# TECHNICAL SERVICE BULLETIN

## Dirt/Dust And/Or Ice Accumulation At The Bottom Inside Of Doors

**18-2339**  
09 November  
2018

<b>Ford</b> 2015-2018 Edge
-------------------------------

Figure 2

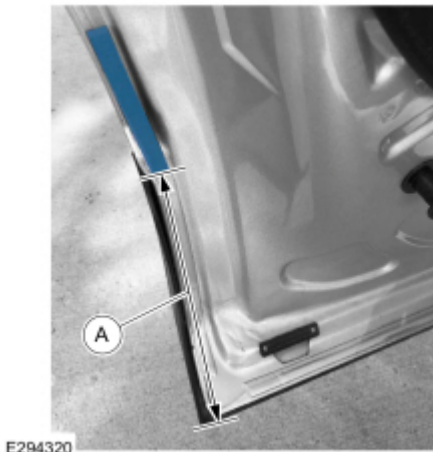
5. Fold a piece of grip tape in half along the long direction. Peel away the tape backing. Starting from the marked position, apply the grip tape around the metal weatherstrip channel, with half of the tape on each side. Press the tape firmly against the channel to fully seat the tape. (Figure 1)
6. Install a new body mounted weatherstrip by starting from the top and pushing the 7 push pins into the door opening frame. Slide the bottom half of the body mounted weatherstrip onto the flange.
7. Using an erasable marker, measure in a straight line and mark a distance of 17.5 cm (7 in) on the inside of the rear door. (Figure 2, Callout A)

8. Peel away the tape backing of the foam patch and apply to the door with the bottom of the tape hitting the marked position. Press the patch firmly to seat it. (Figure 2)
9. Raise the vehicle. Refer to WSM, Section 100-02.
10. Using a non-marring trim removal tool (RTTP or equivalent), remove the 9 push pins securing the lower door weatherstrip assembly.
11. Replace the lower door weatherstrip assemblies by starting from the front and pushing the 9 push pins under the lower door channel. (Figure 3)

Figure 4

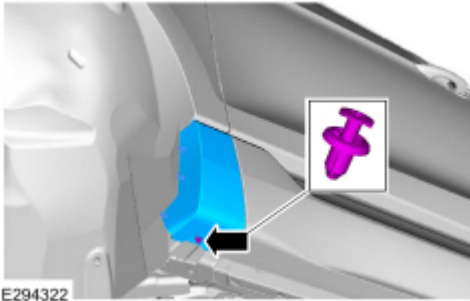
13. On both sides, remove and discard the lower retainers from the left and right side rocker panel moulding end caps located behind the front tires. (Figure 4)
